# Access Compliance Report

## Public Rights-of-Way

Intersection ID: 2598	Main Street: DRISCOLL_CT	Cross Street: LAGRANDE_DR	Location: SE
ADA ID: E2822ED073D6	Ramp Type: BlendTrans1	Initial Pass/Fail: Fail	Overall Compliance: No
Severity Score: 8.75			
Codes/Mitigation Info/Possible Solution		Field Measurements/Component Compliance

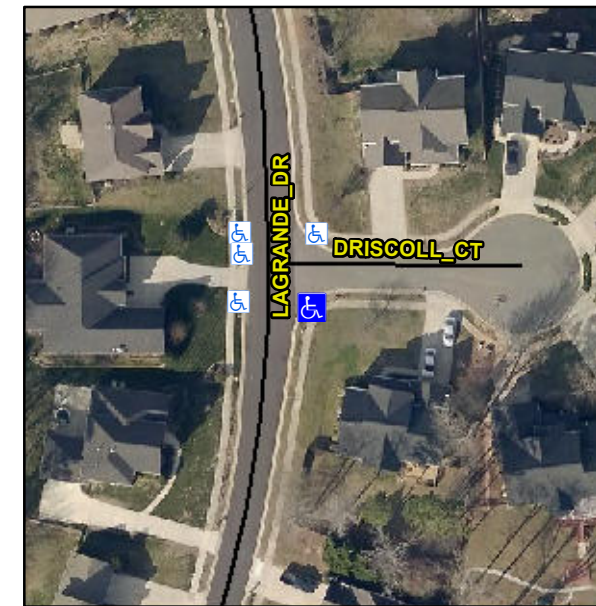
**Not Found, R304.5.1**

Compliance	Description	Data	Compliance	Description	Data
N/A	Ramp Length (in)	46.0	Yes	BlendTrans Slope (%)	2.8
No	Ramp Width (in)	45.0	Yes	BlendTrans XSlope (%)	2.0
N/A	Flare Type LT	N/A	N/A	Flare Type RT	N/A
N/A	Flare Slope LT (%)	N/A	N/A	Flare Slope RT (%)	N/A
N/A	Flare Traversable LT?	N/A	N/A	Flare Traversable RT?	N/A
N/A	Landing Length (in)	N/A	N/A	DWS Provided?	N/A
N/A	Landing Width (in)	N/A	N/A	DWS Contrast?	N/A
N/A	Landing Slope (%)	N/A	N/A	DWS Length (in)	N/A
N/A	Landing X Slope (%)	N/A	N/A	DWS Full Width?	N/A
N/A	Landing Curb? (Y/N)	N/A	N/A	DWS Offset (in)	N/A
N/A	Shared Landing?	N/A			
N/A	Gutter Ponding?	N/A	N/A	Gutter Slope (%)	N/A
N/A	Gutter Lip Ht (in)	N/A	N/A	Gutter X Slope (%)	N/A
N/A	Painted X Walk1?	No	N/A	Painted X Walk2?	No
	X Walk 1 Direction	To N		X Walk 2 Direction	To W
	X Walk 1 Width (in)	N/A		X Walk 2 Width (in)	N/A
	X Walk 1 Slope (%)	1.9		X Walk 2 Slope (%)	2.0
	X Walk 1 X Slope (%)	2.4		X Walk 2 X Slope (%)	3.1

N/A	Ramp inside XWalk1?	N/A	N/A	Ramp inside XWalk2?	N/A
	Road Slope (%)	1.0		Clear Space?	N/A
	Road X Slope (%)	6.7	N/A	Clear Space to XWalk (in)	N/A
N/A	Any Obstructions?	N/A	N/A	Storm Grate/Utility Hazard?	N/A
	Obstruction Type			Storm Grate/Utility Type	
		N/A			N/A
			Yes	Surface Condition? (G/P)	Good
			No	Curb Slope (%)	9.0

**Remove & Replace Curb Ramp With Two New Directional Ramps or Equivalent.**
